ENCLOSURE 1

NRC DOCKETS 50-321, 50-366
OPERATING LICENSES DPR-57, NPF-5
EDWIN I. HATCH NUCLEAR PLANT UNITS 1, 2
REQUEST TO REVISE TECHNICAL SPECIFICATIONS
DRYWELL PNEUMATIC MODIFICATIONS

The proposed changes revise Table 3.7-4 of the Unit 1 Technical Specifications and Table 3.6.3-1 of the Unit 2 Technical Specifications to add or delete primary containment isolation valves. The changes reflect drywell pneumatic system modifications planned for implementation in Unit 1 during the Fall 1985 refueling outage and already completed in Unit 2.

FIGURE 1a
ORIGINAL CONFIGURATION

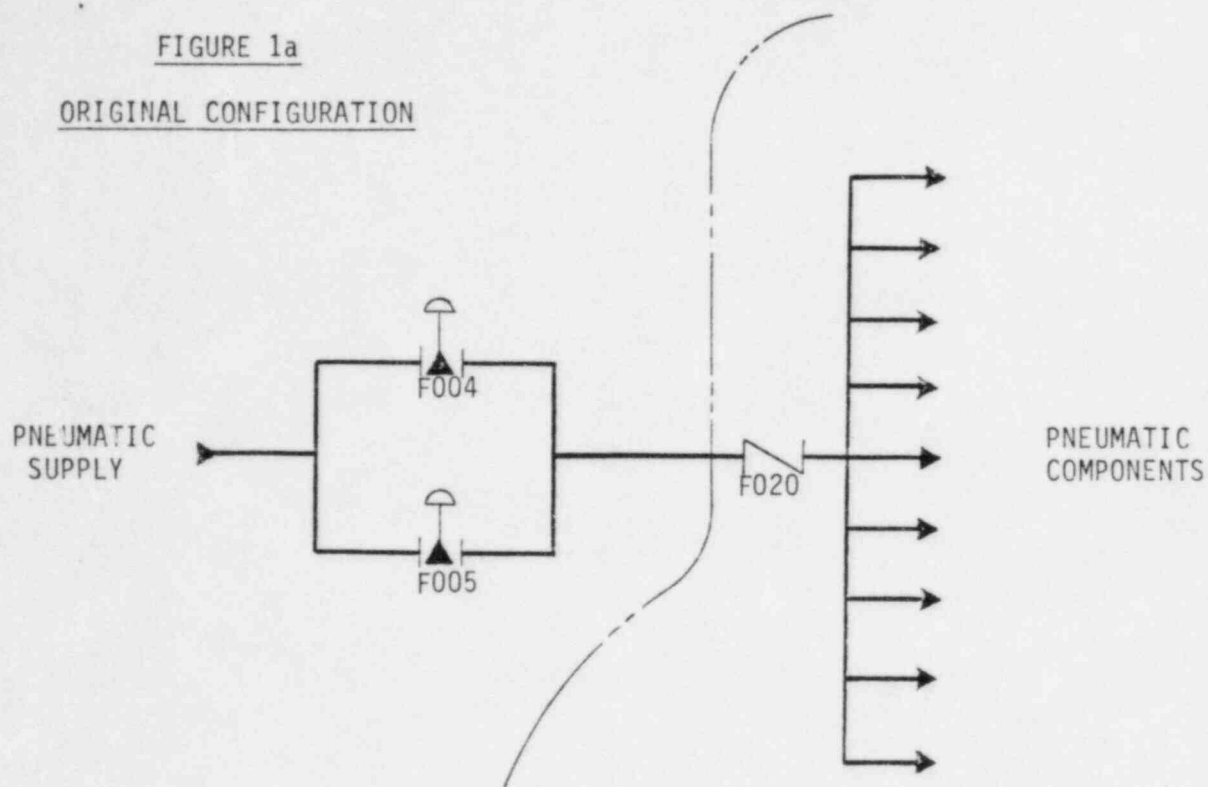
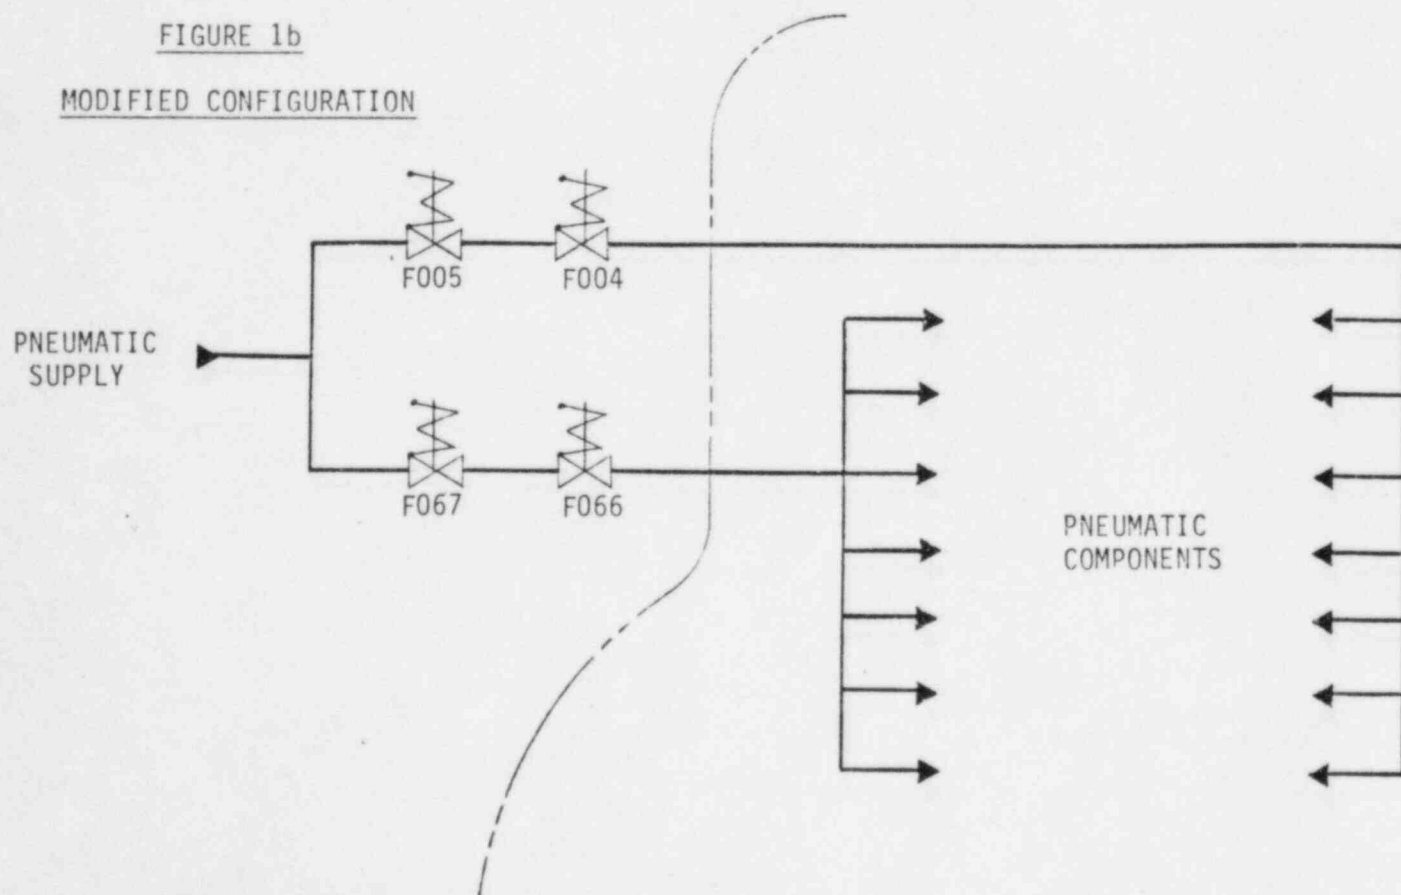
The modification divides the original single drywell pneumatic header into two separate headers which penetrate the drywell at different locations. Each header supplies approximately half of the safety/relief valves. The headers are routed such that no high energy line break could damage both headers, thus assuring a long-term pneumatic supply to some safety/relief valves.

Containment isolation, provided in the original design by valves P70/2P70-F004 and F005 in a parallel arrangement (and check valve 2P70-F020 in Unit 2), is provided in the modified system by valves P70/2P70-F004 and F005 on one header and P70/2P70-F066 and F067 on the other header. Figure 1 provides a simplified diagram of the original and modified isolation valve configurations.

Add valves 2P70-F066 and F067 to Table 3.6.3-1 of the Unit 2 Technical Specifications. Delete valve 2P70-F020 from Table 3.6.3-1.
